Sent: 14/08/2021 12:06:48 PM
Subject: URGENT Planning & Development - DA2021/1183
Attachments: 53050-1 survey.pdf;

ISSUE	DATE	AMENDMENT
TITLE: PLAN SHOWING SELECTED DETAIL & LEVELS OVER No.14B BATE AVENUE, ALLAMBIE HEIGHTS		
LGA:	NORTHERN BEACHES	REFERENCE: 53050
CLIENT :	MRS NICOLE RANDO	DATE: 29-6-21
SCALE (AT A1) 1:150	DATUM : AHD	SURVEYOR: AW
		SHEET 1
Norton Survey Partners SURVEYORS & LAND TITLE CONSULTANTS A.C.N. 618 988 475 SUITE 1 505 BULWAIN ROAD LILFIELD N.S.W. 2040 PH +61 2 9555 2744 office@nortonpartners.com.au

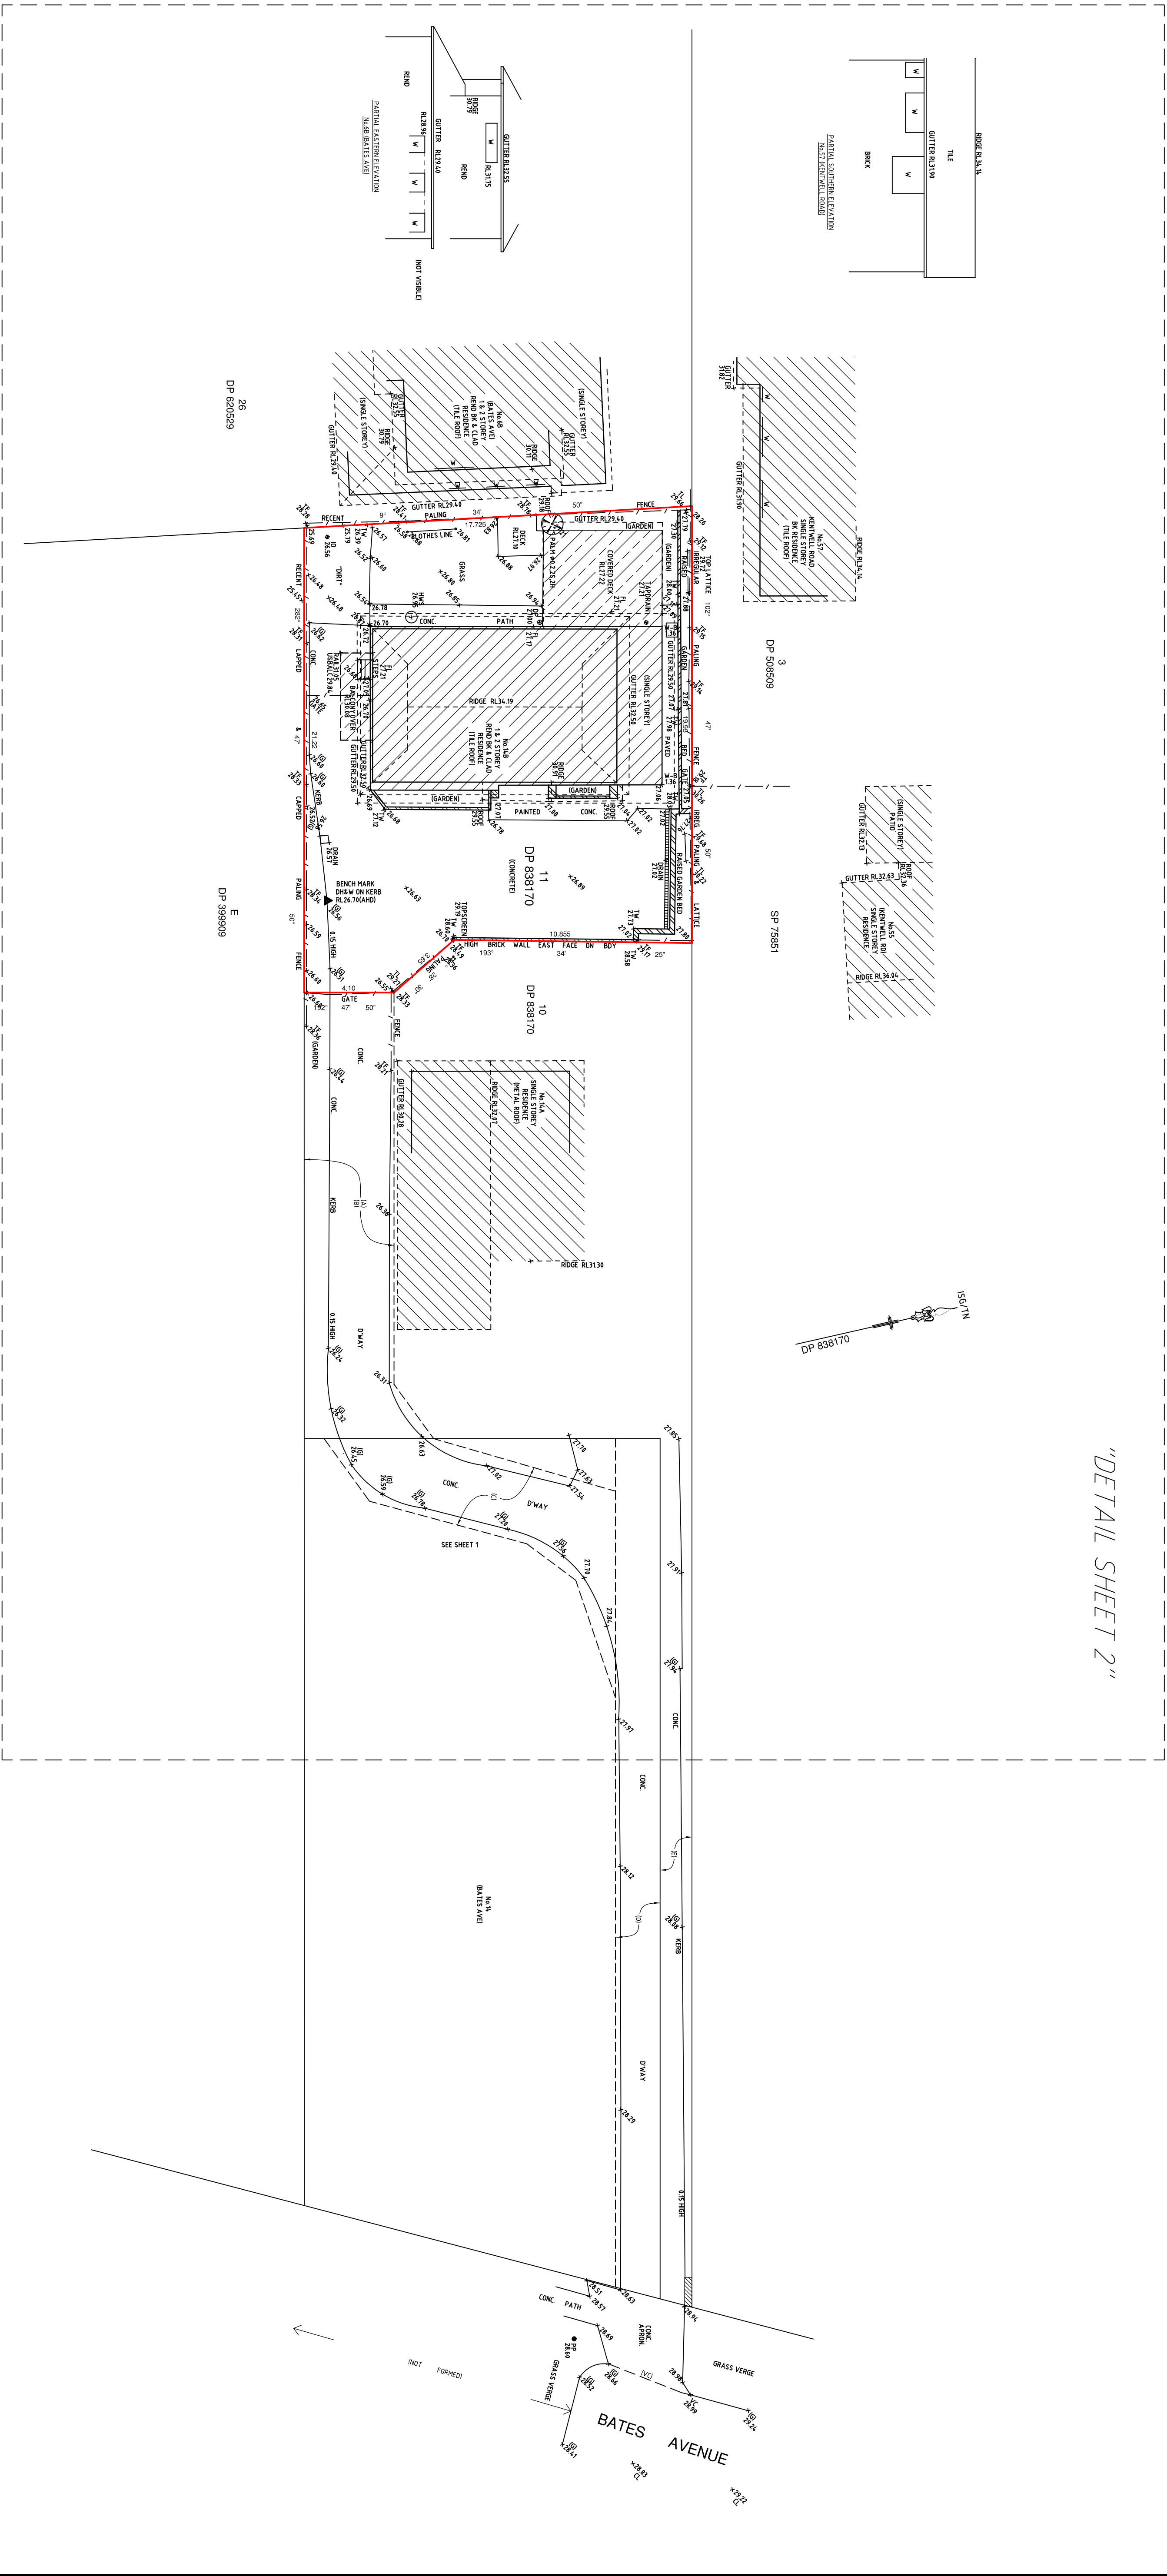
The Applicants' rear boundary (at the northern end of their block, I believe) is our side boundary. This is where the granny flat is proposed to be built. The total length of our shared boundary is 21.22m. The length of the granny flat roof (excluding its entrance platform / steps) would be 20m, a total of 94% (approx.) of the length of our shared boundary. **The residence being so close - a proposed 2m from the boundary fence** - would create a sense of enclosure for us, which is unwelcome and quite contrary to when we bought the house. Please see attached for a recent survey of our property.

We kindly request a site visit before a decision is made on this application please. On site, you'll appreciate that we'd be nearly able to touch the granny flat wall from our front yard, all the way along the length of our property (i.e. front to back). Having someone live that close would be incredibly intrusive: the building itself, the occupants' noise and their windows looking directly into our private living space.
